**TOWN OF MOUNTAIN VILLAGE
REGULAR DESIGN REVIEW BOARD MEETING AGENDA
THURSDAY MARCH 30, 2023 10:00 AM
MOUNTAIN VILLAGE TOWN HALL
455 MOUNTAIN VILLAGE BLVD, MOUNTAIN VILLAGE, COLORADO
TO BE HELD HYBRID THROUGH ZOOM:**

**DESIGN REVIEW BOARD MINUTES
TOWN OF MOUNTAIN VILLAGE
REGULAR DESIGN REVIEW BOARD MEETING
MARCH 2, 2023**

BUILDING SITE PLAN

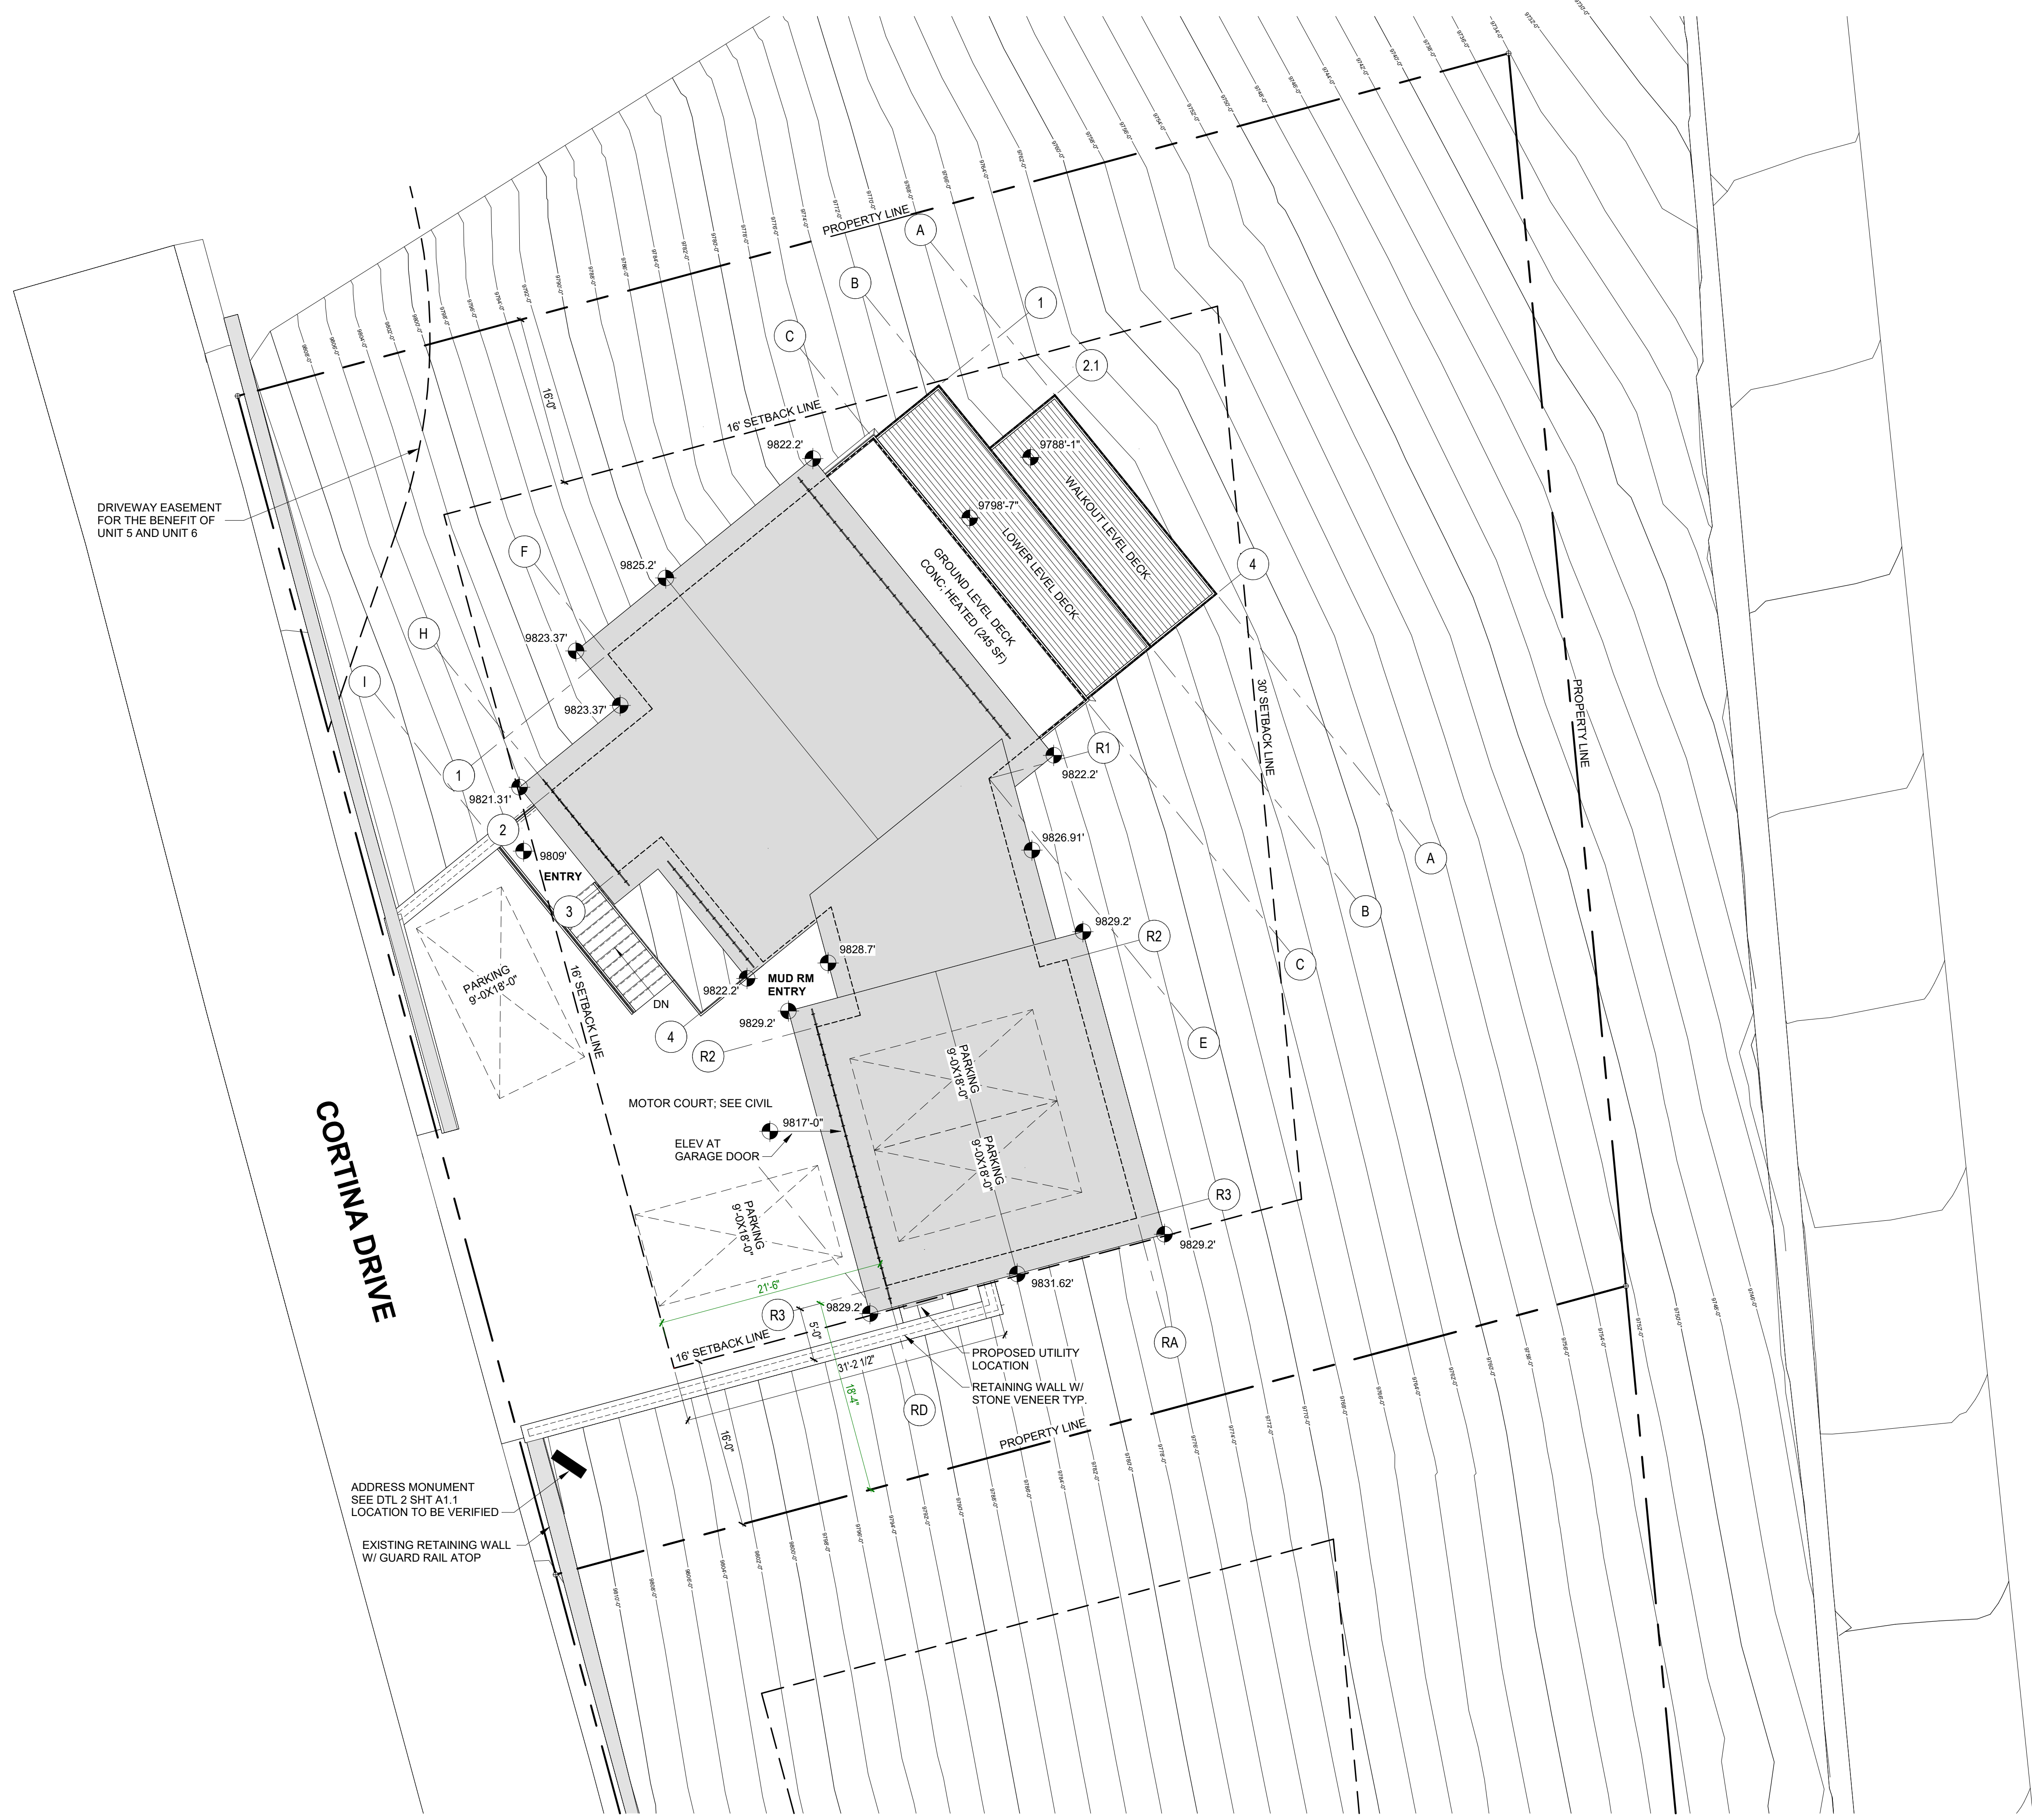
- *Exterior Parking: One of the exterior parking spaces is located entirely in the lot setback as shown on sheet A1.2 of Exhibit A and highlighted in red in Figure 2.*

L-101

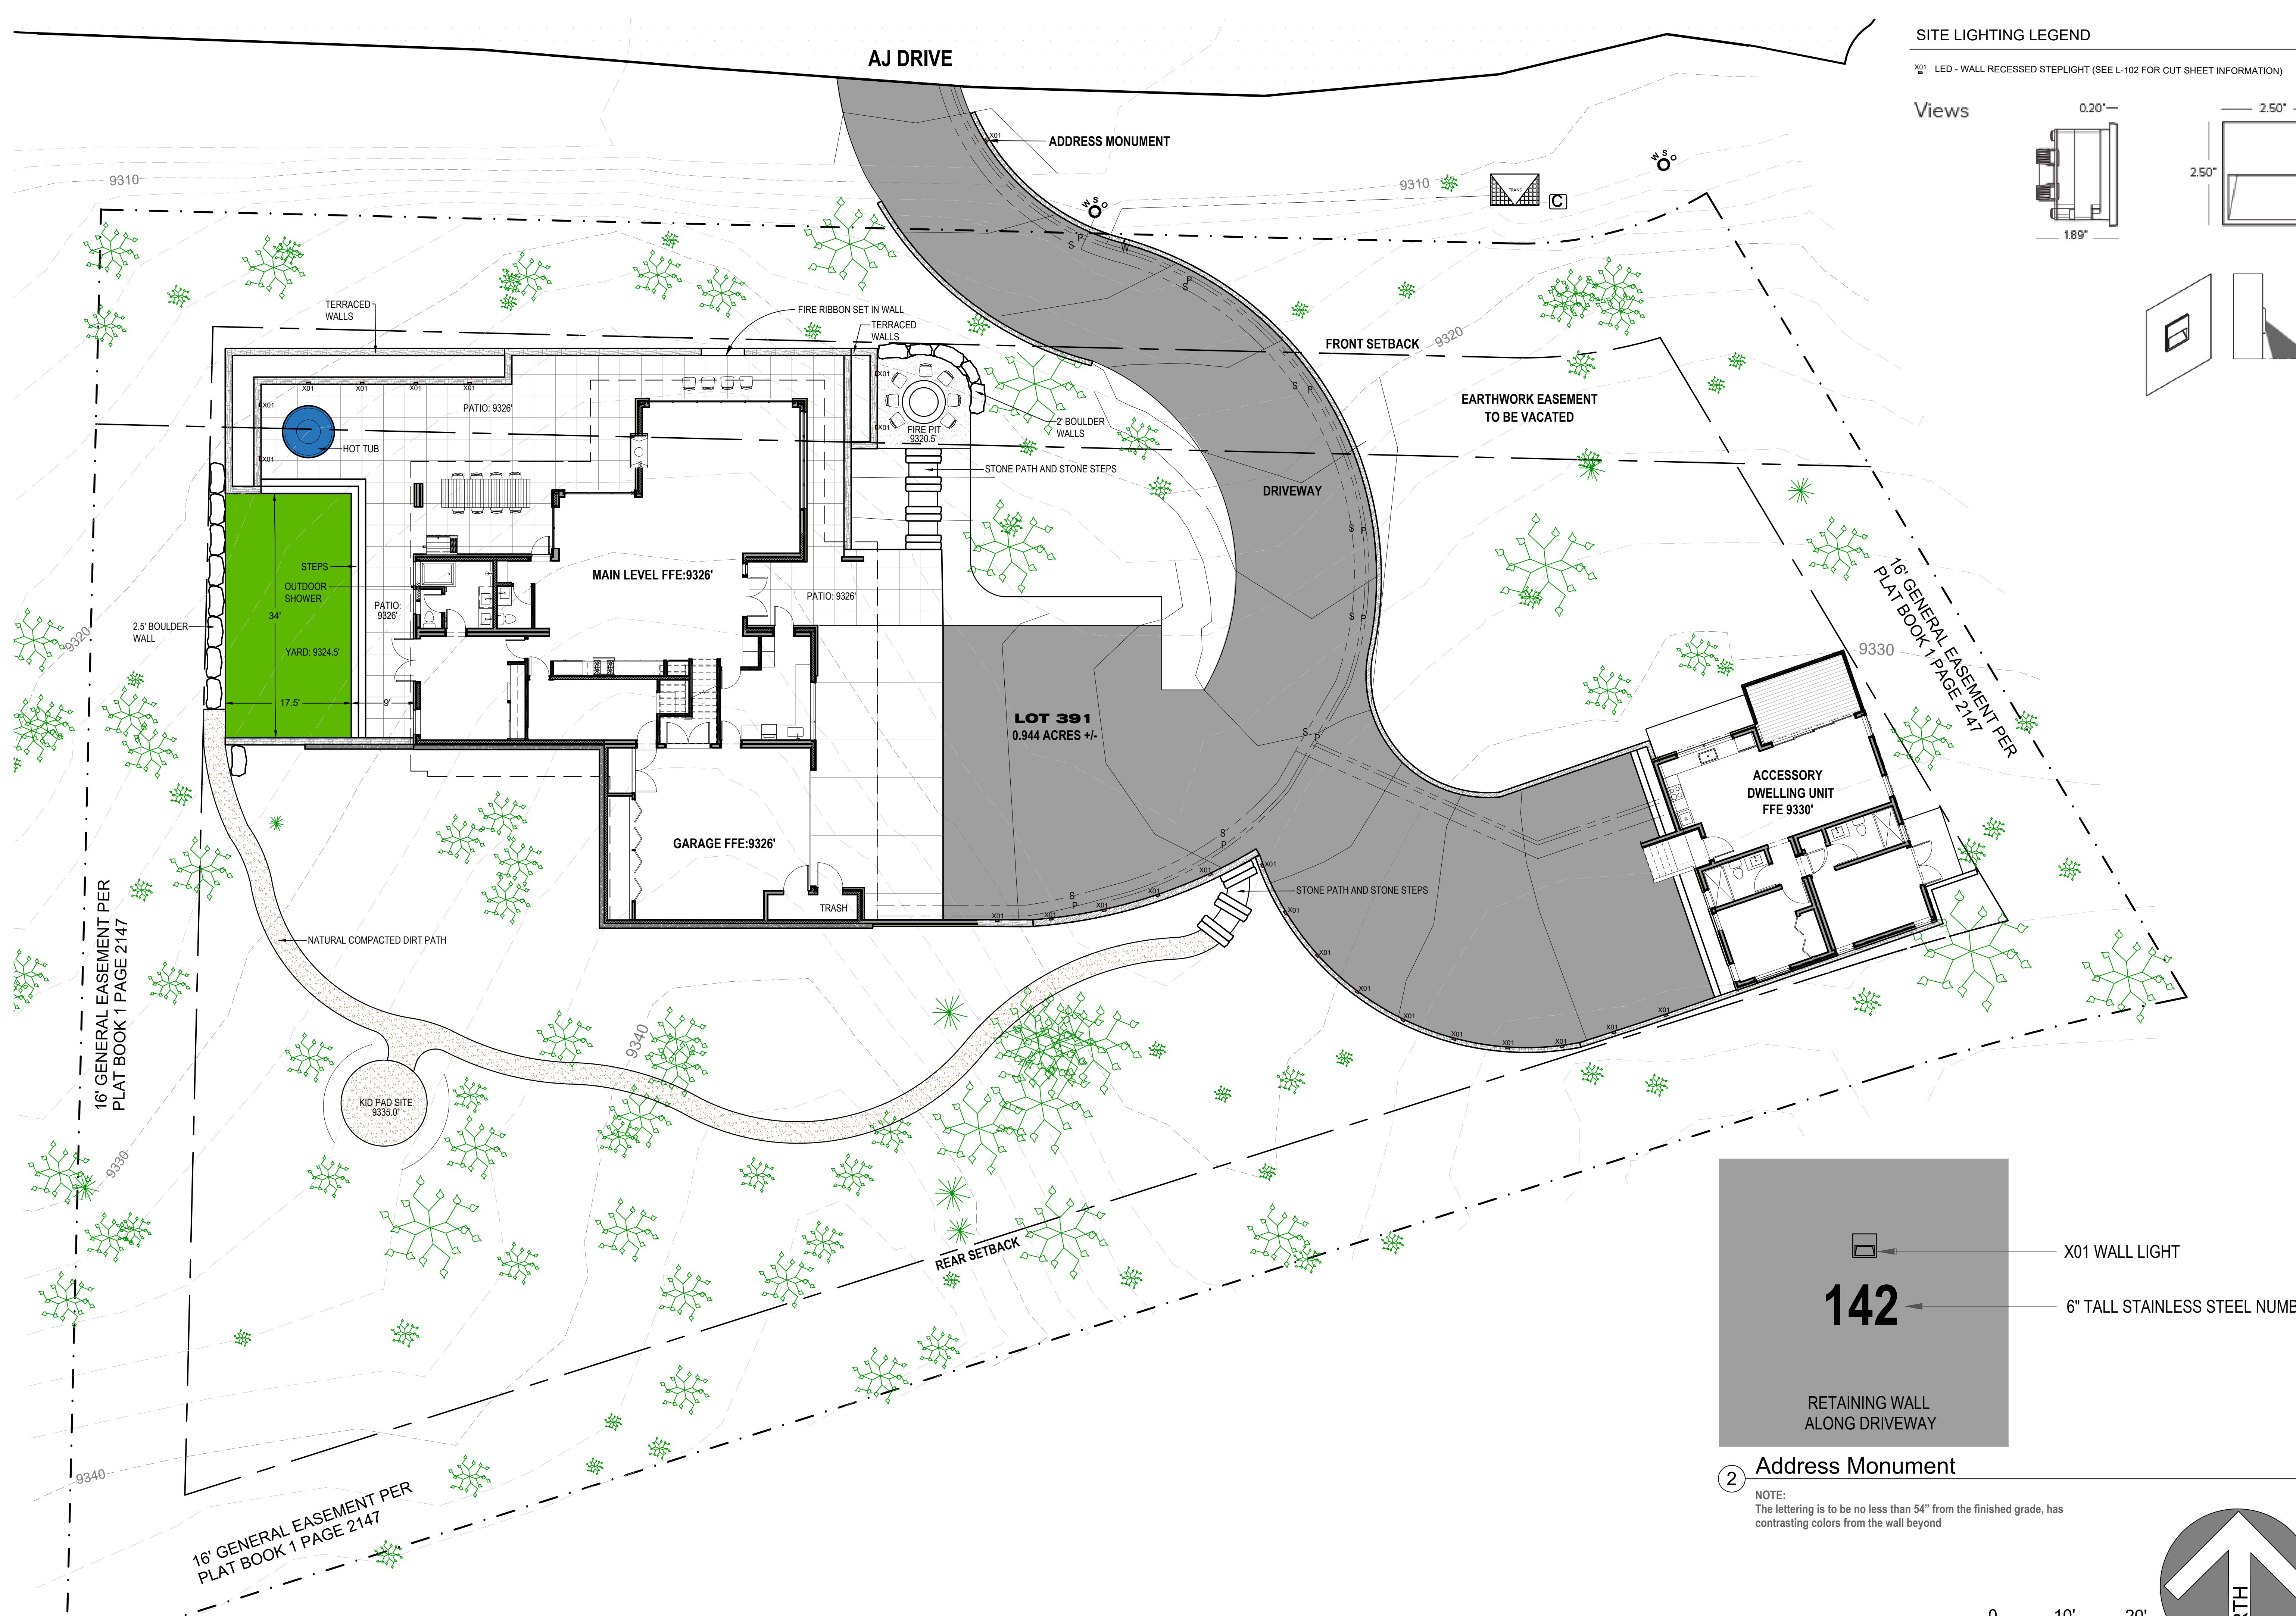
Staff: The application materials have been updated to include the location and materials of the address monument. An address monument is proposed to be attached to the stone retaining wall located in the right of way, shown on Sheet L100. Insignificant encroachments in the road right of way are approvable by DRB as a specific approval. Any development within the right of way will require the owner and the Town to enter into an Encroachment Agreement as part of a condition of approval.

A004

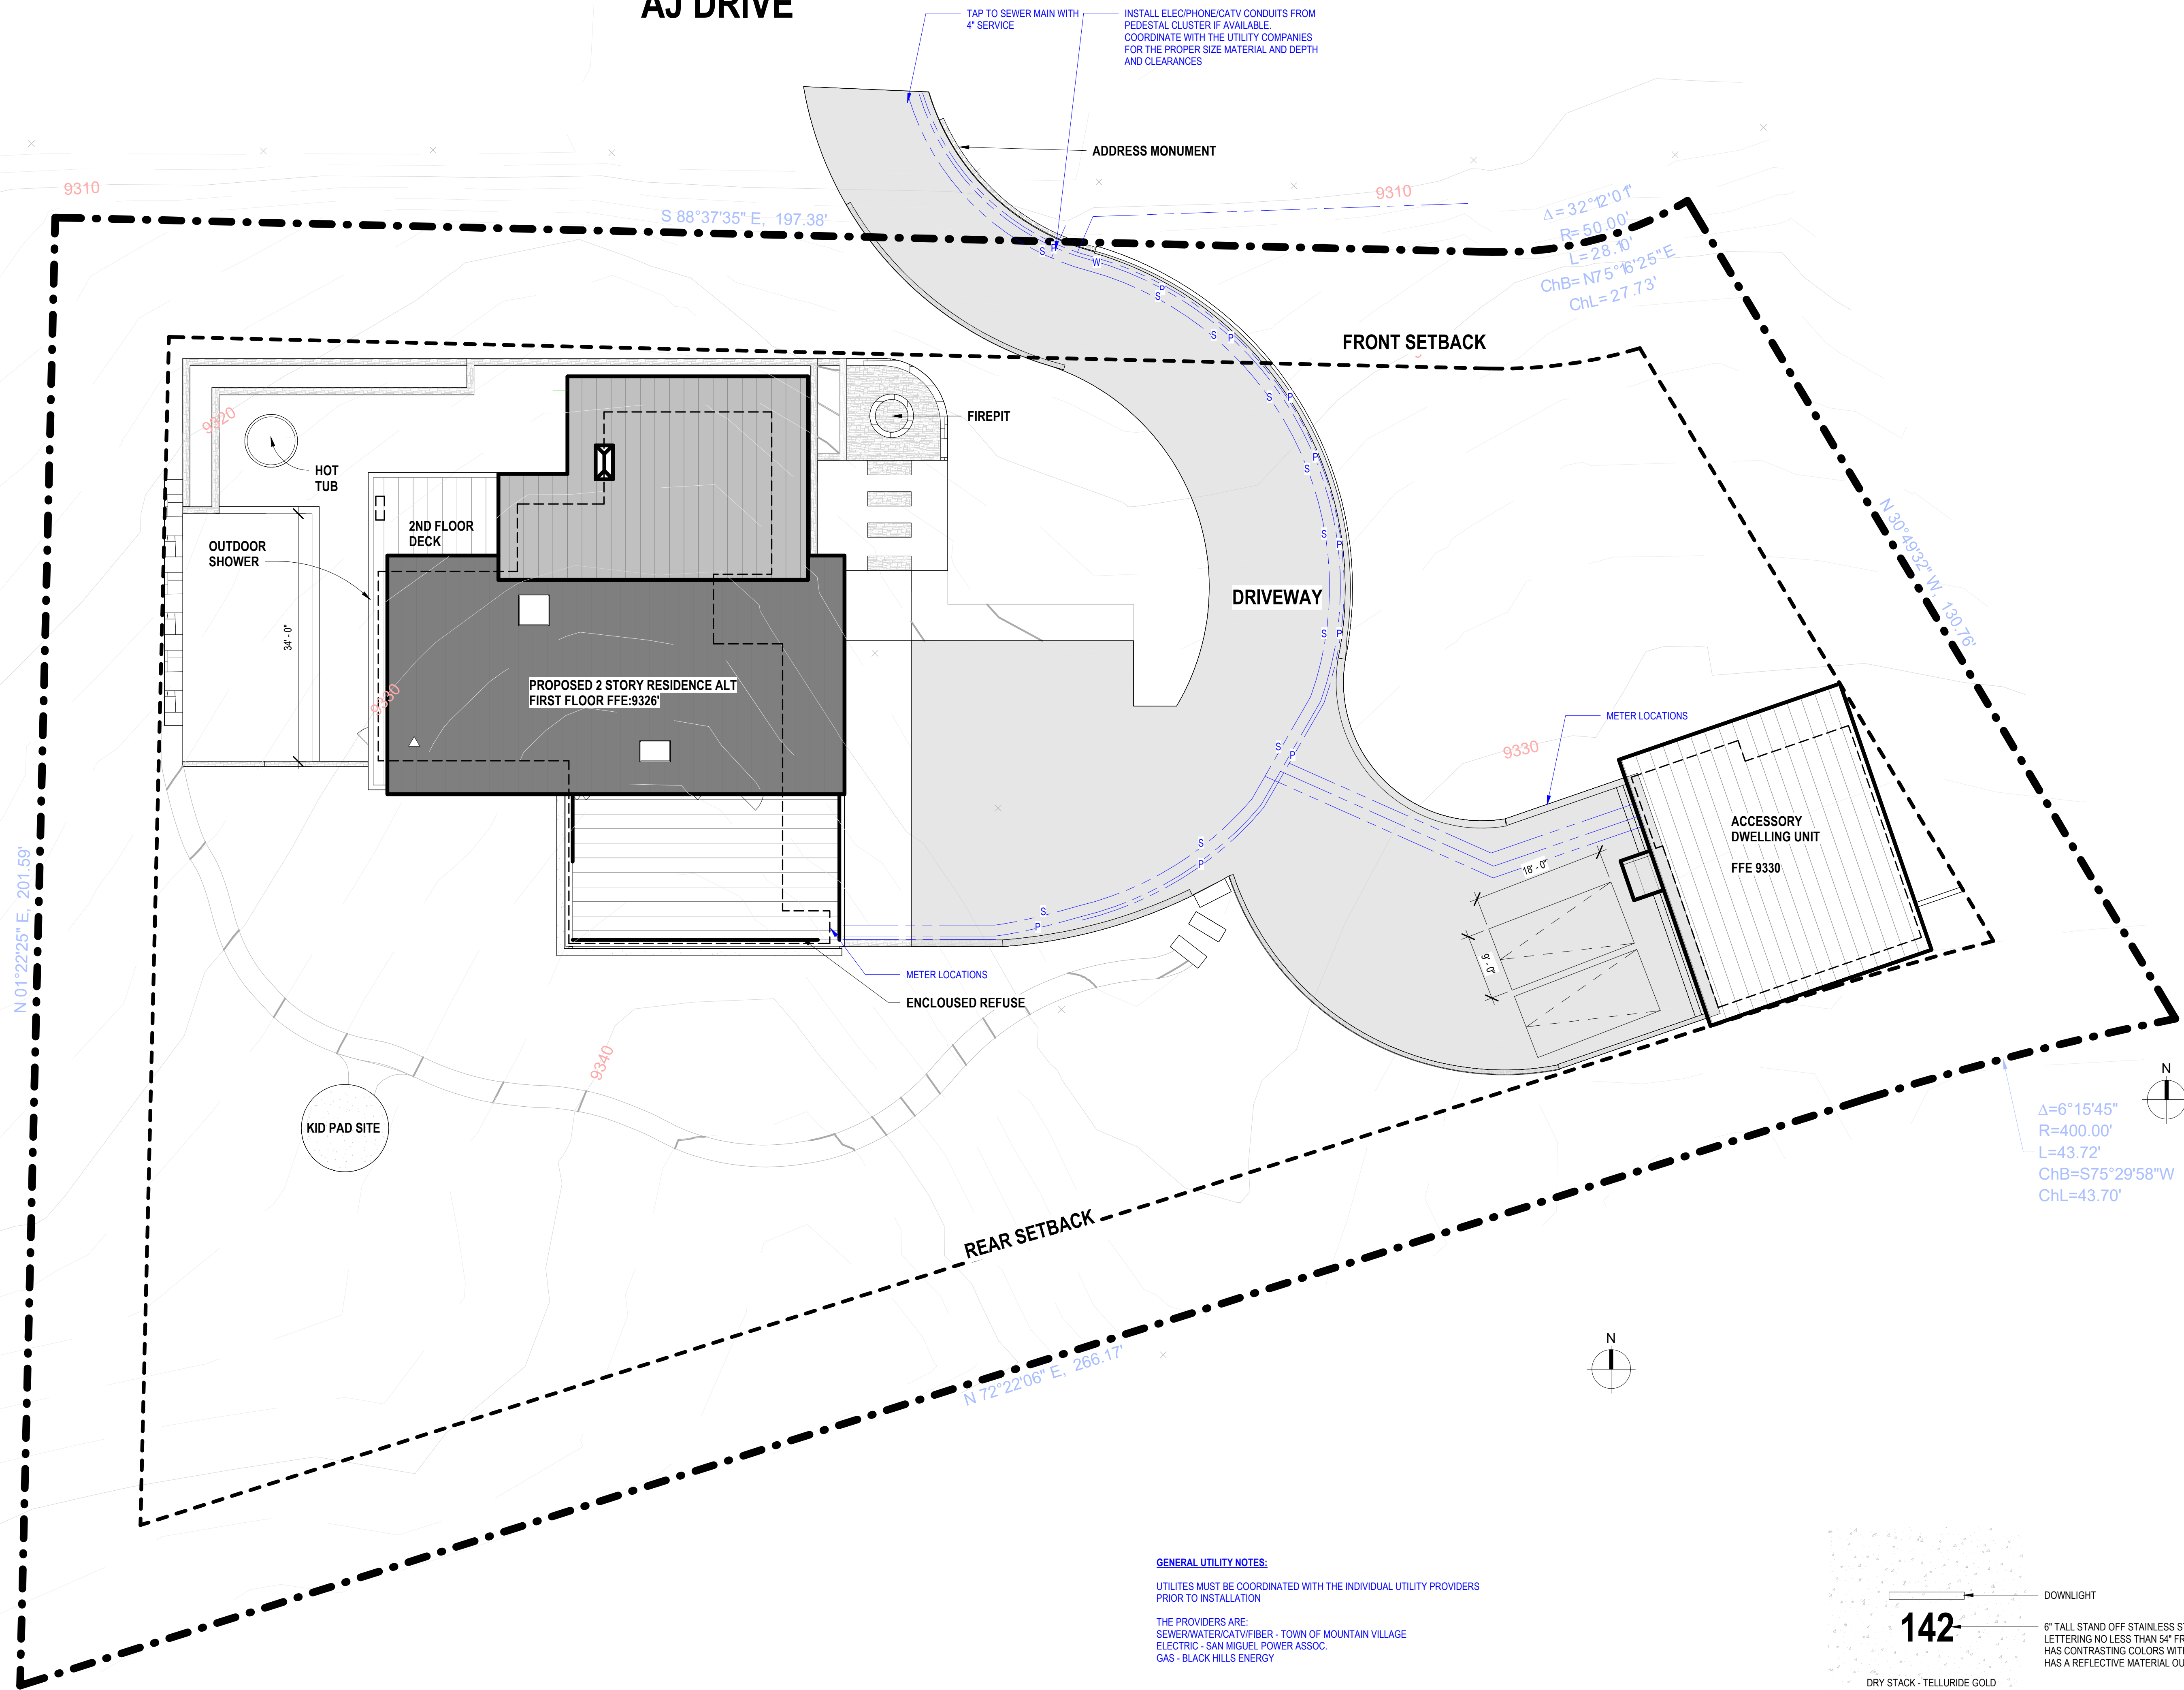
Staff: The utility plan is provided on Sheet A005. The plan shows that the proposed water, phone, electric, and sewer lines will cross the northern property line and will connect to existing lines on AJ Drive and then follow the driveway up to the structures. The applicant
